The 55 details drawn differently in CAD and Revit

Checked against the new drafters' file, 26 October.

55 of the 190 CAD typical details have a Revit version in your templates that is drawn differently. Each page: your CAD detail on the left, the Revit version on the right, what differs, and one answer: CAD is right, Revit is newer (we update CAD from it), or both wrong.

53 of 55 CAD: KOR-S302-DET 12 - TYPICAL DIAGONALLY REINFORCED HEADER DETAIL

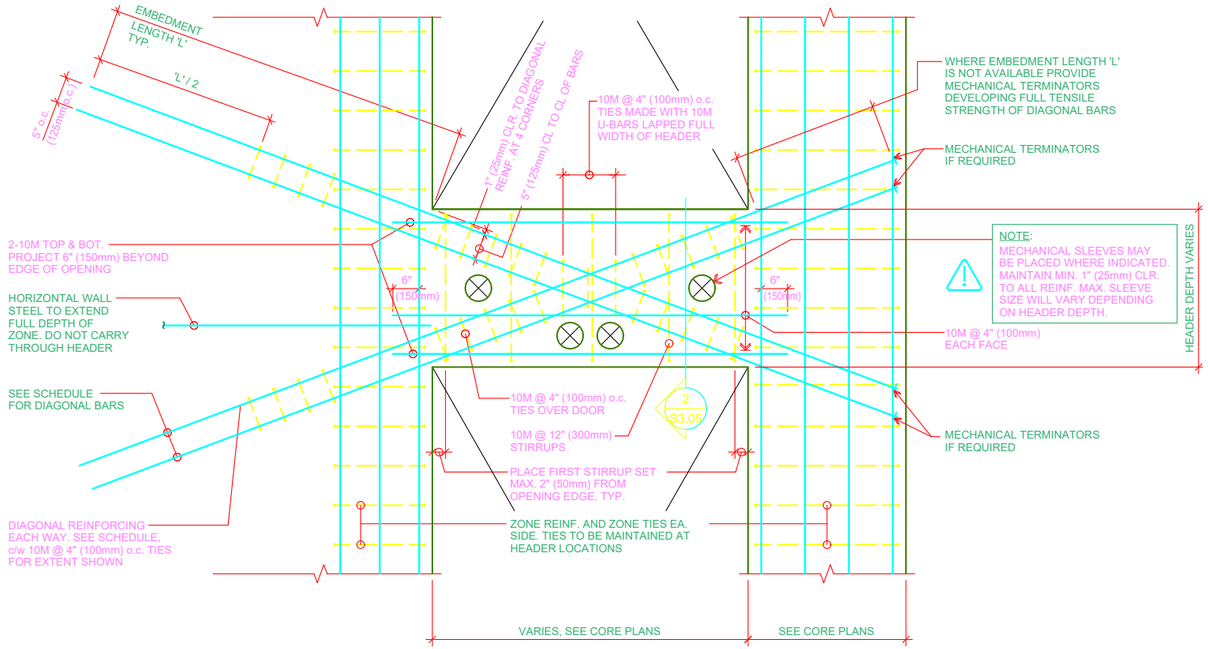
What differs: CAD is a larger, project-specific 40in/53in deep header elevation with mechanical terminators and sleeve notes and no embedment tables; '1E3.05_1_TYPICAL DIAGONALLY REINFORCED HEADER DETAIL' is the generic version with tables.
